PTS STANDARDS - 100 SERIES DRAWINGS
STANDARDS FOR ROADWAY CONSTRUCTION
APRIL 2022 EDITION – CHANGE NO. 2 – NOVEMBER 2023

PTS – 100 SERIES DRAWINGS

PENNSYLVANIA TURNPIKE COMMISSION
INDEX OF STANDARDS FOR ROADWAY CONSTRUCTION

SECTION C-C

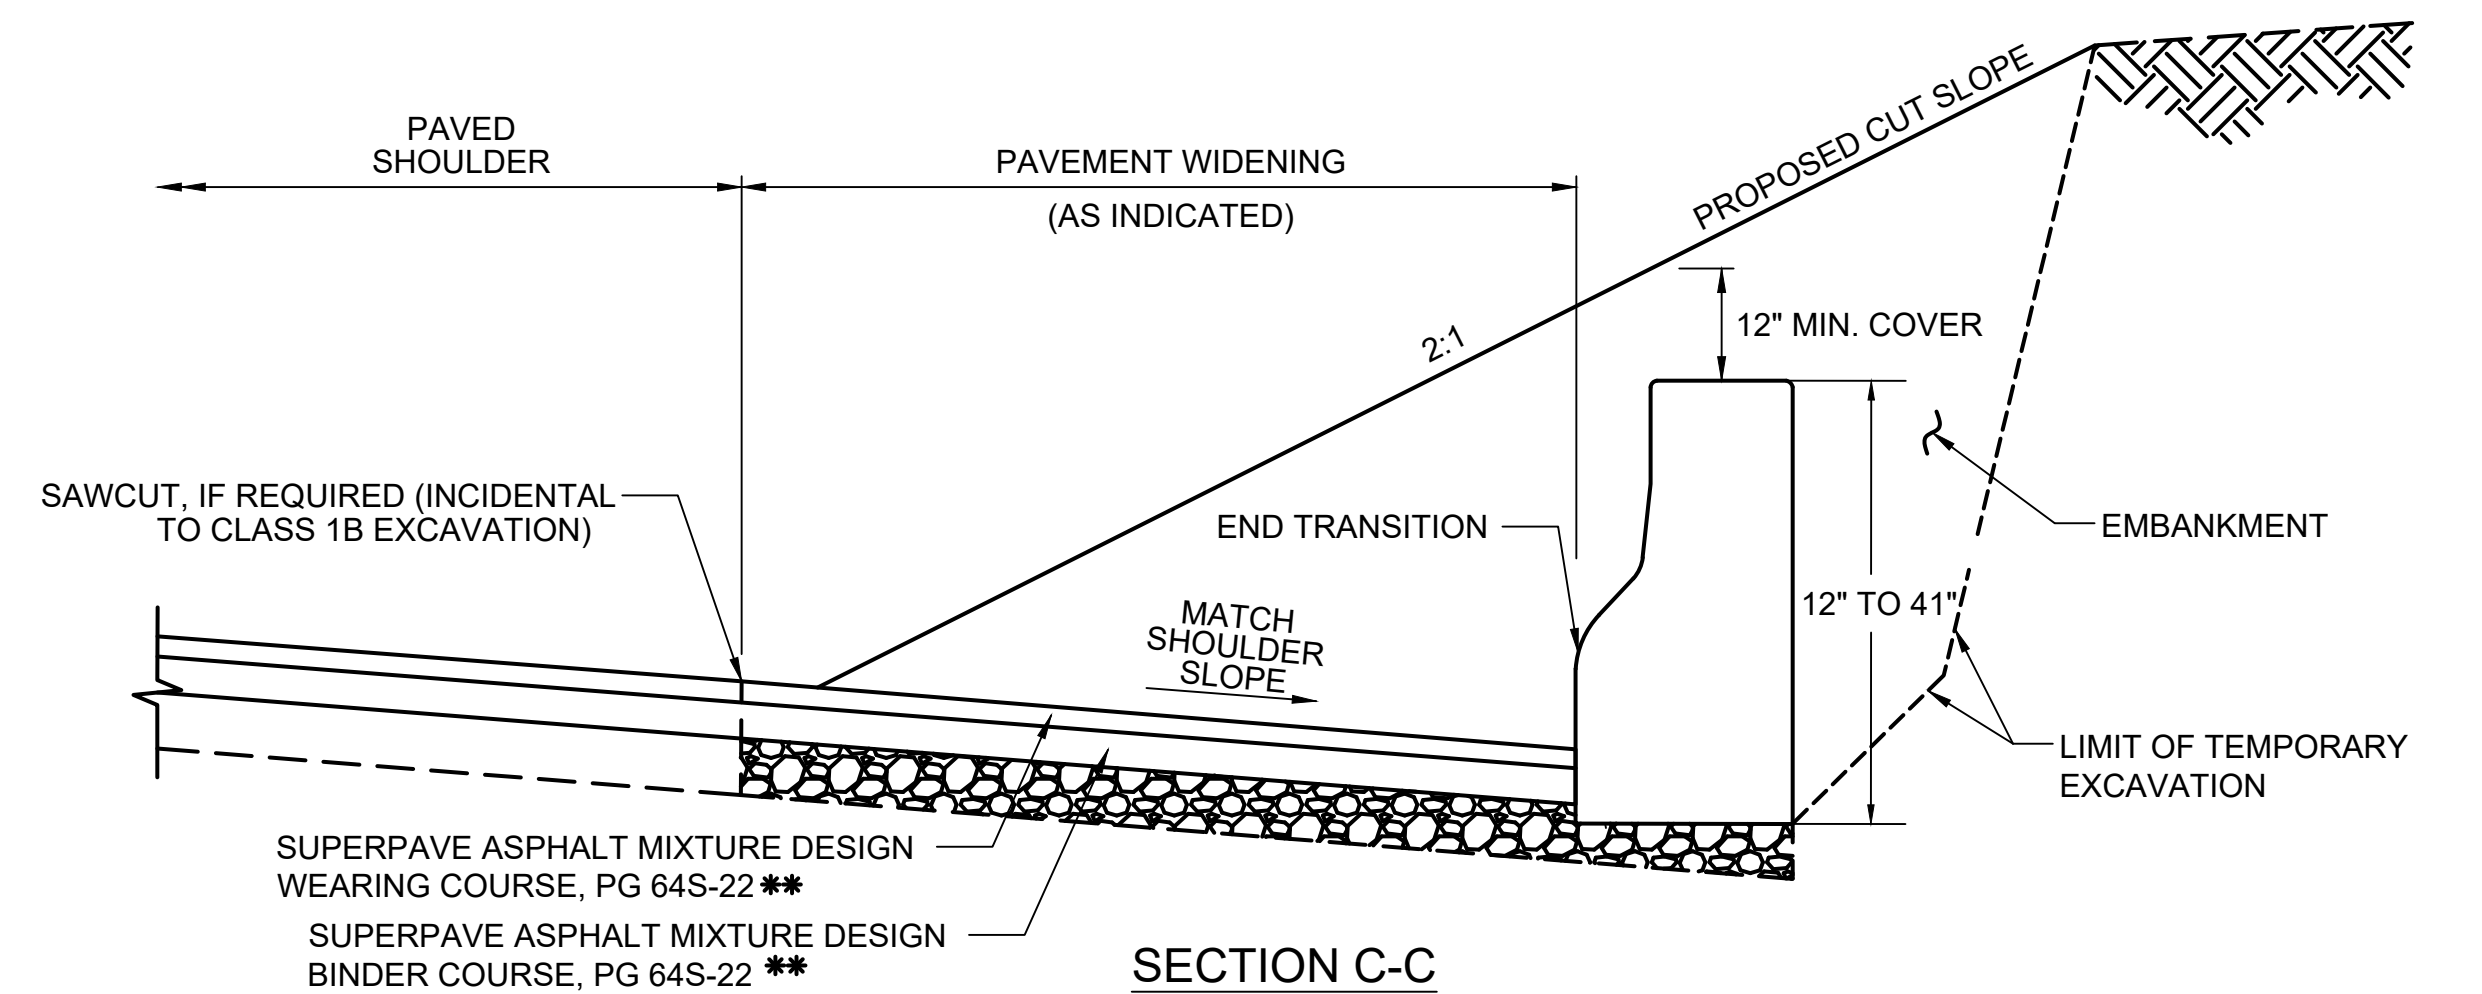
ADDED A PROFILE VIEW.
REVISED THE PLAN VIEW TO INDICATE THE REFERENCE SECTION LOCATIONS.
ALIGNED SECTION VIEWS VERTICALLY AND ADDED A PATTERN TO THE SUBBASE LAYER.

FILE NAME: PTS-145-1.dwg
DRAWING TYPE: 5A

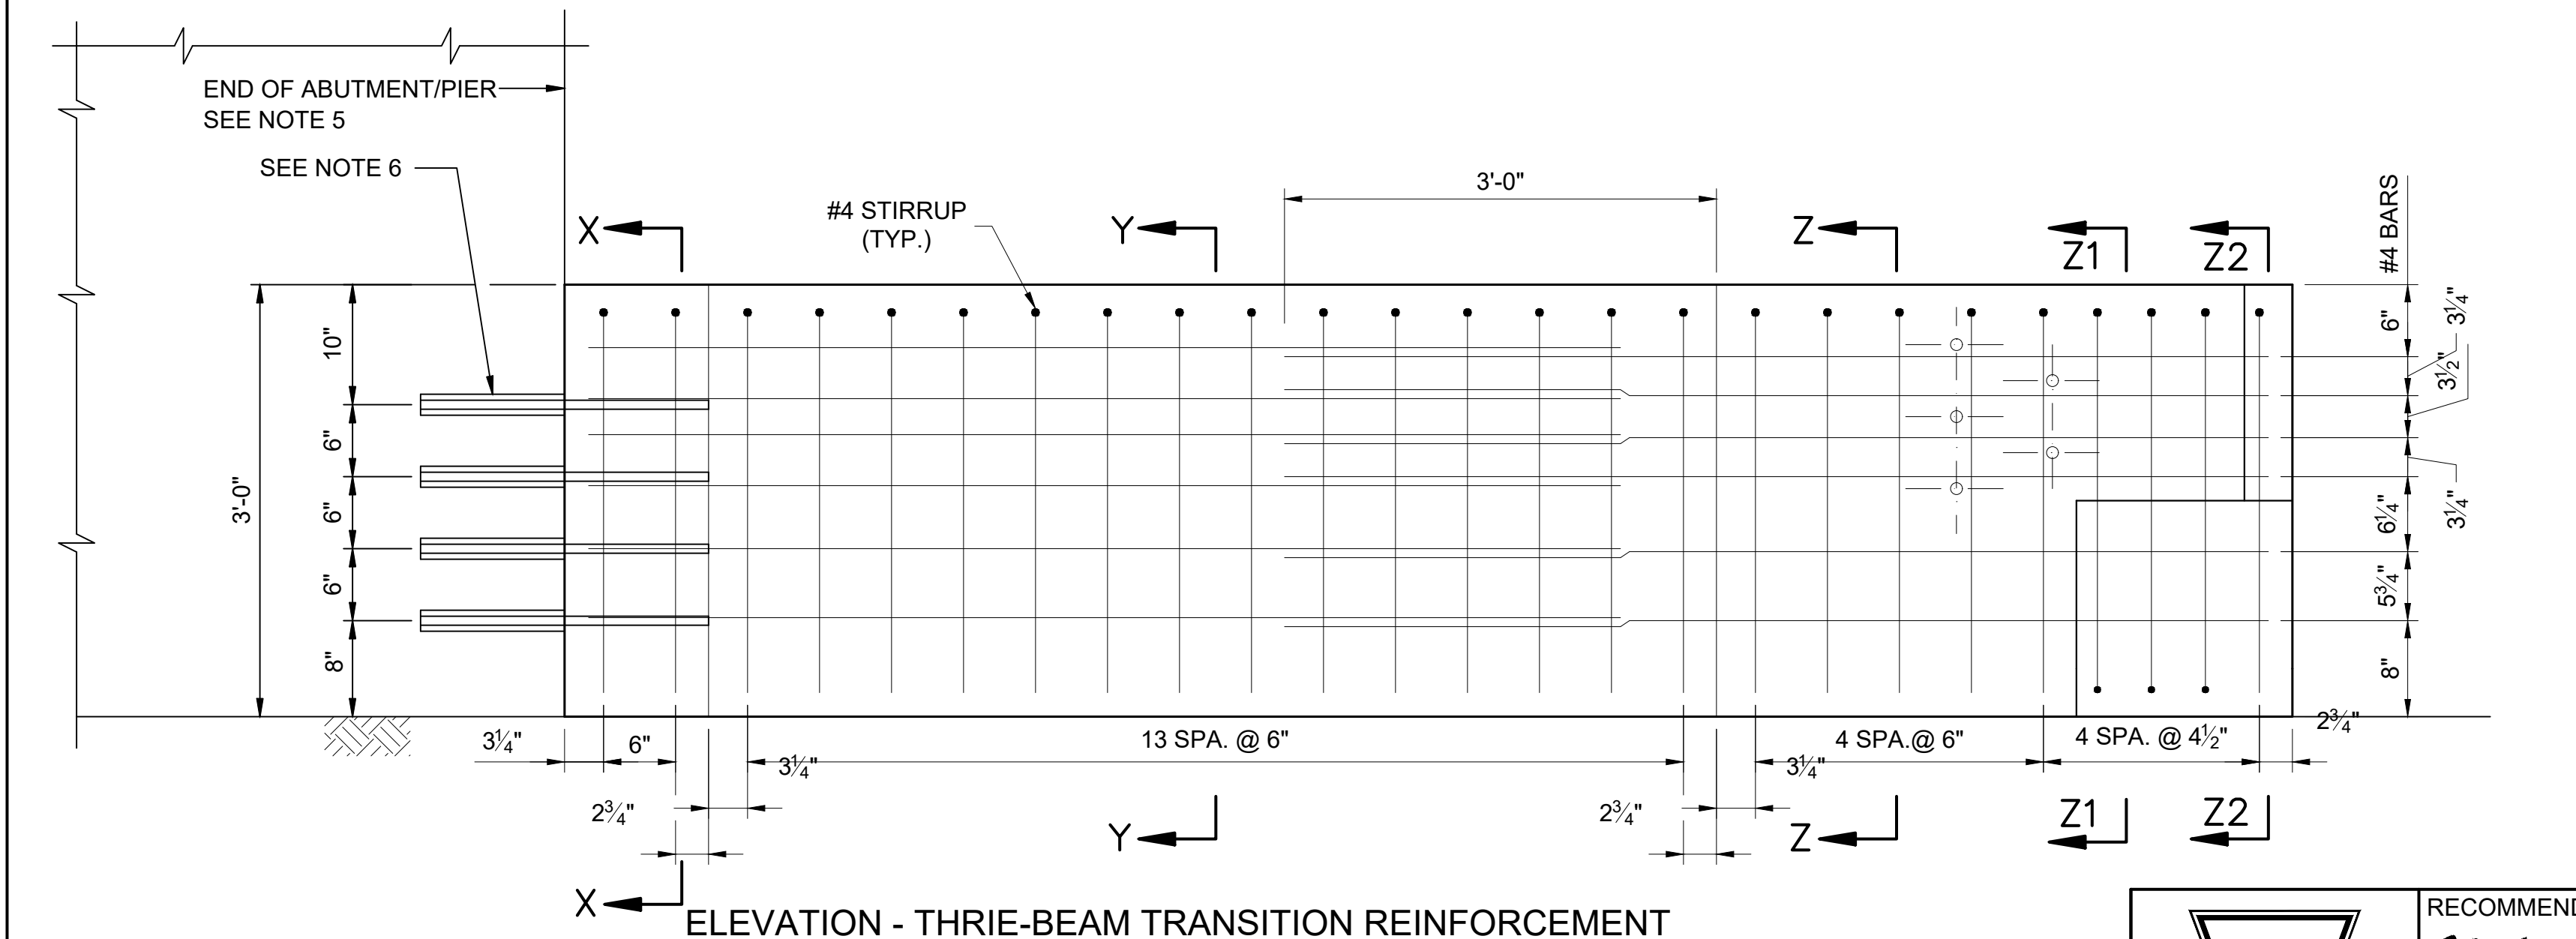
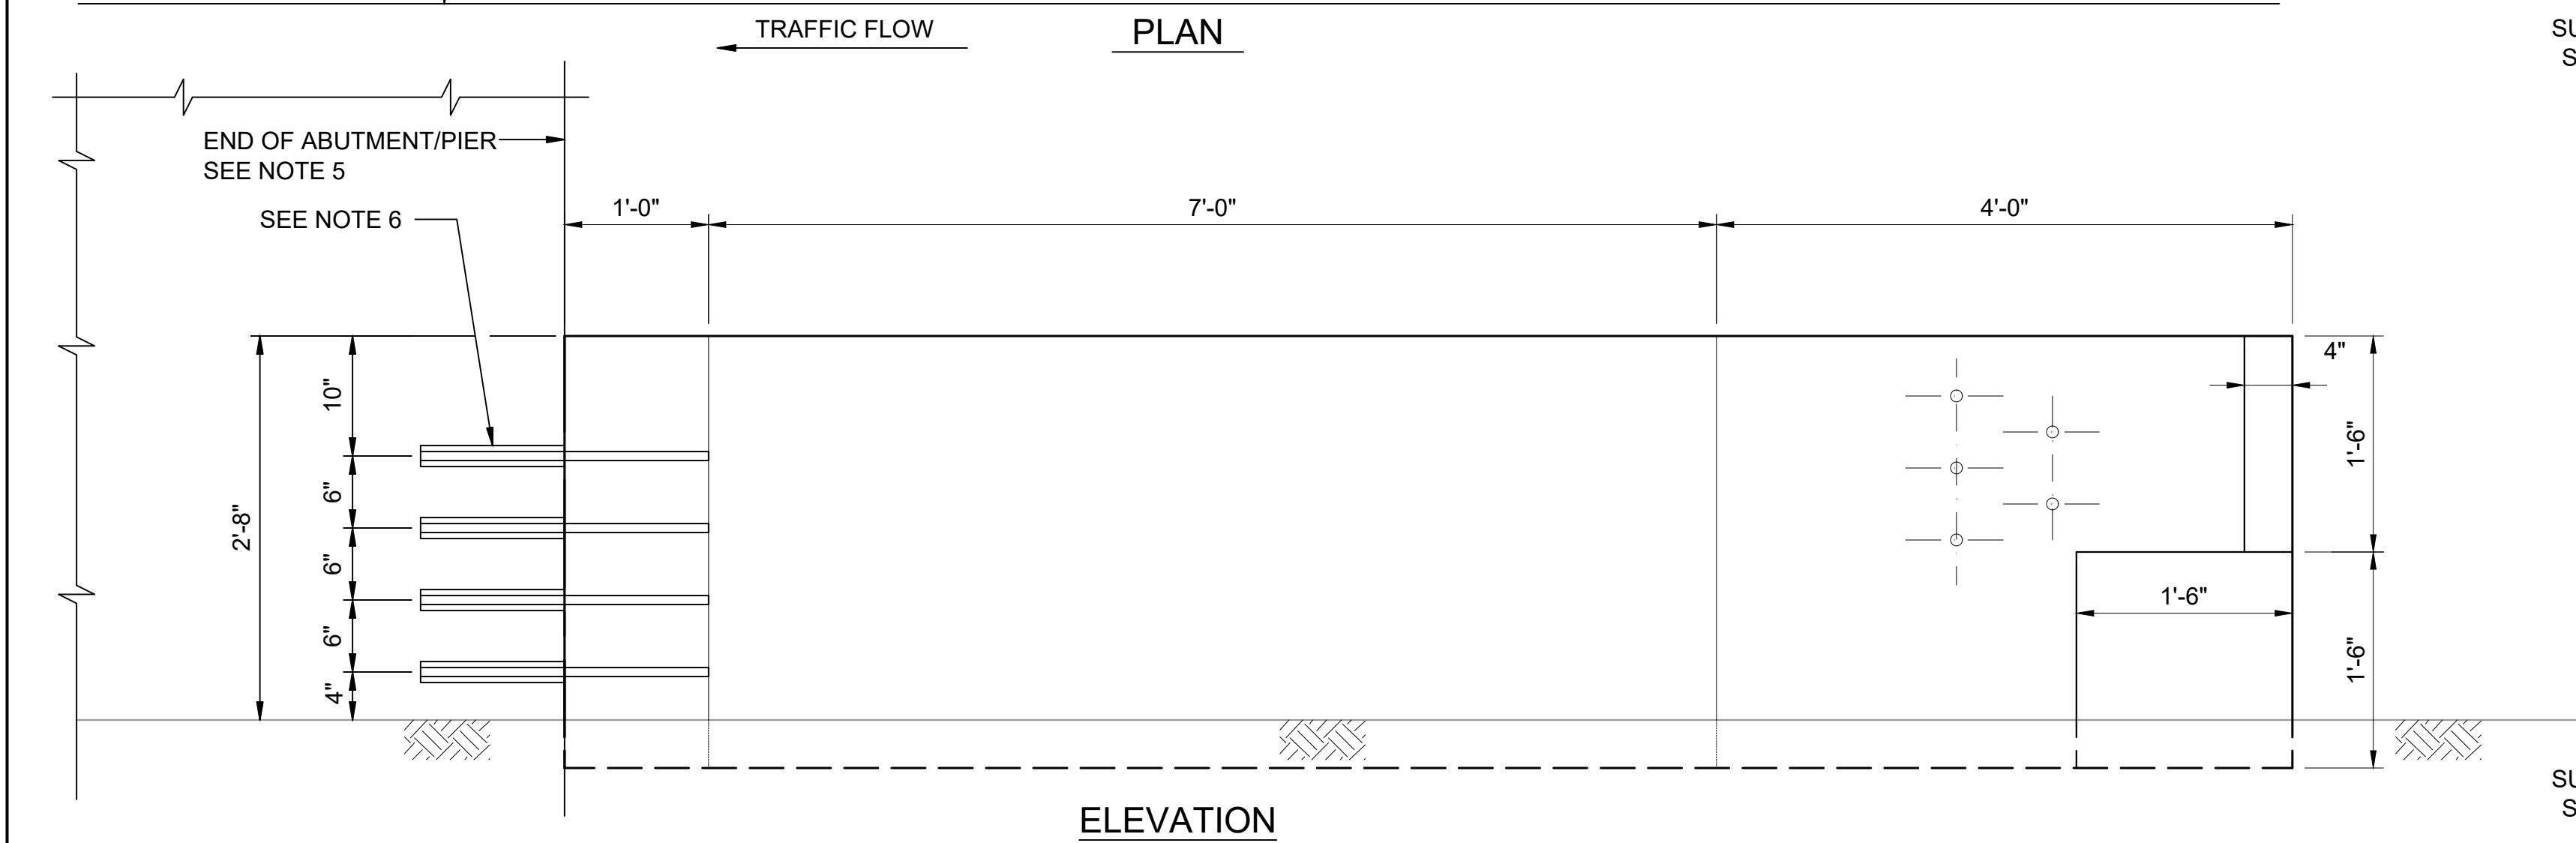
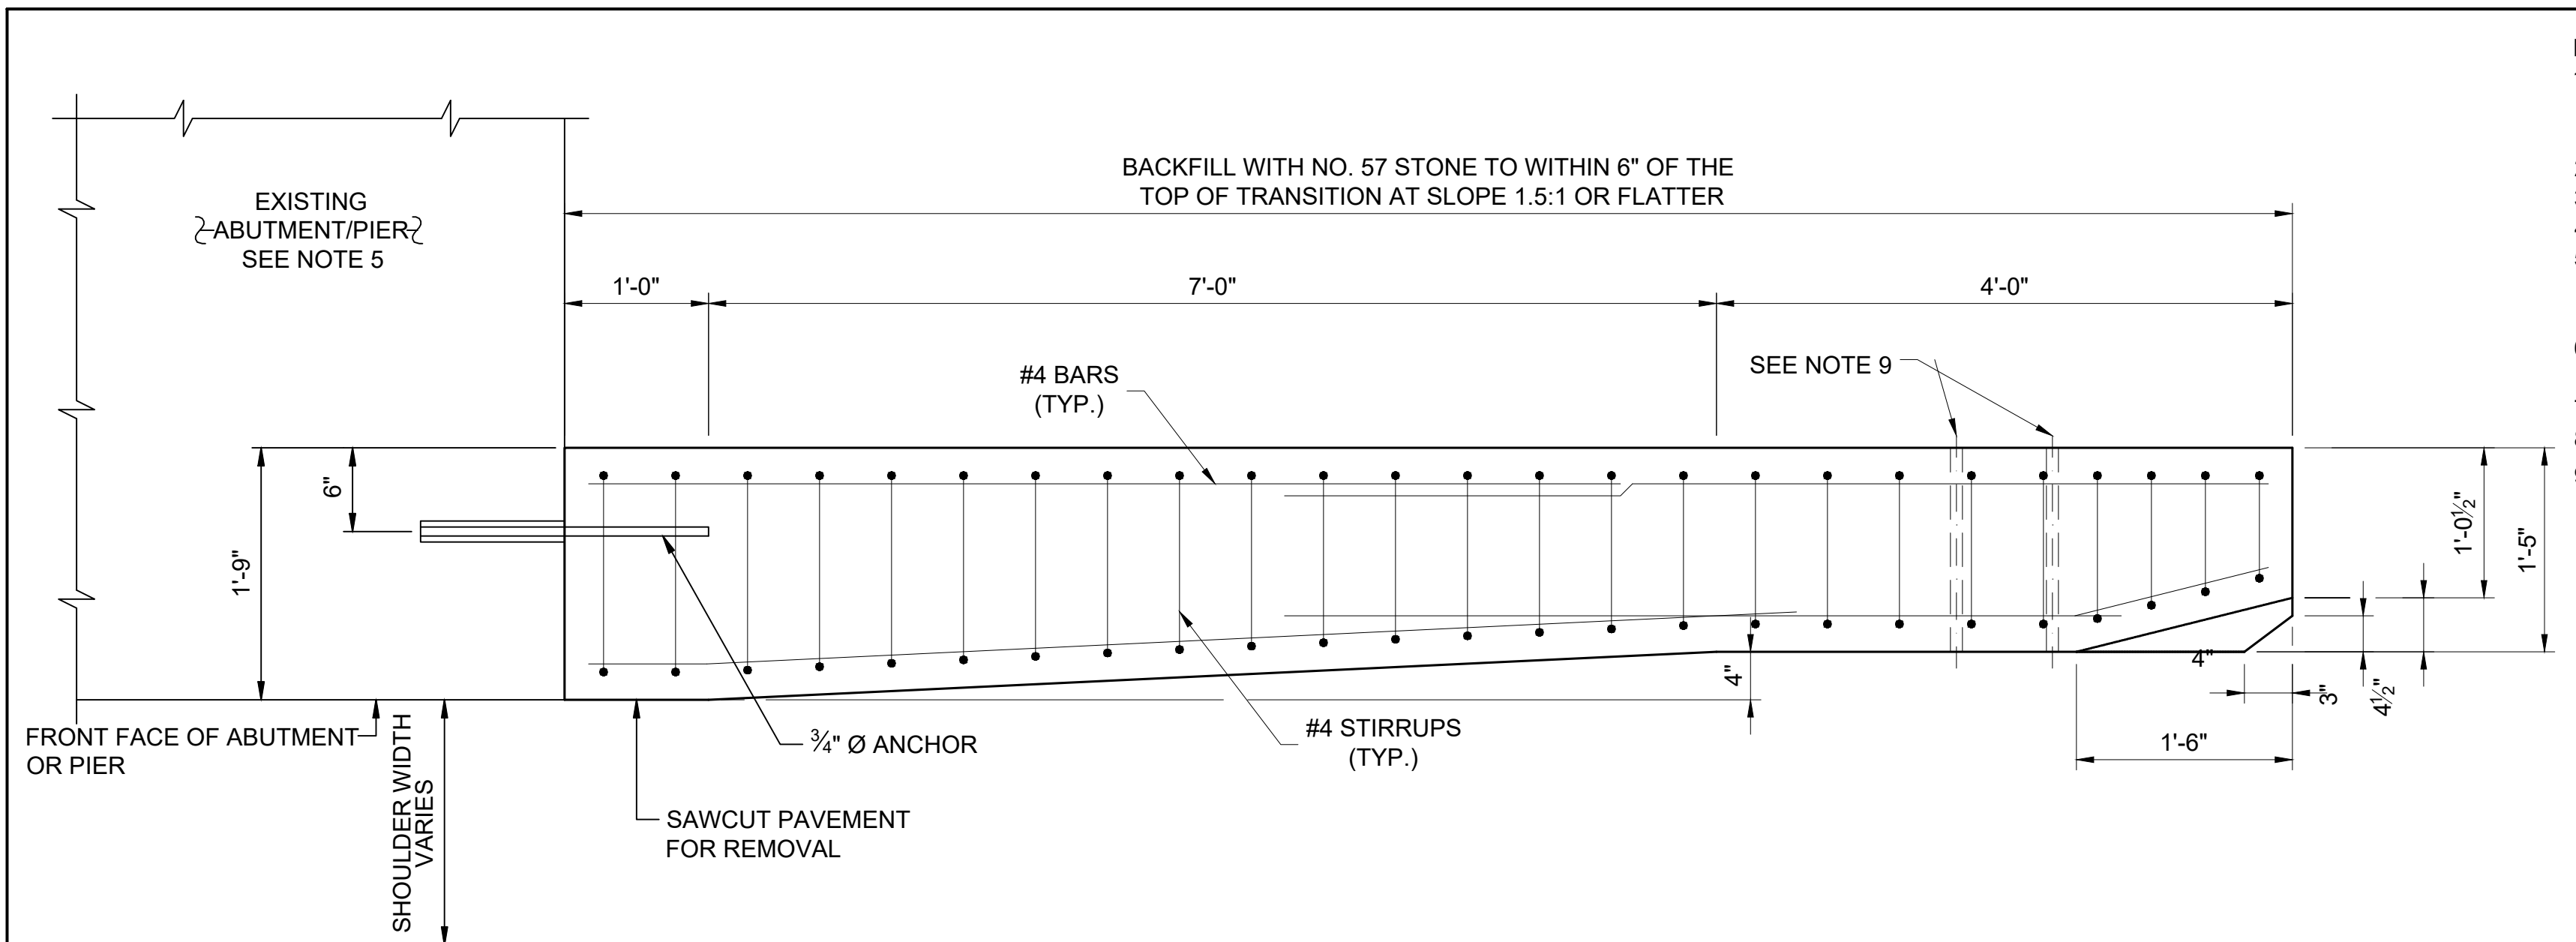
SECTION X-X – REVISED DIMENSION OFFSET FOR ANCHORS.
ADDED THE USE OF A PACHOMETER TO THE NOTES.

CALLOUT FOR "BACKFILL WITH NO. 57 STONE" ADDED "TO WITHIN 6" OF THE TOP OF THE TRANSITION".
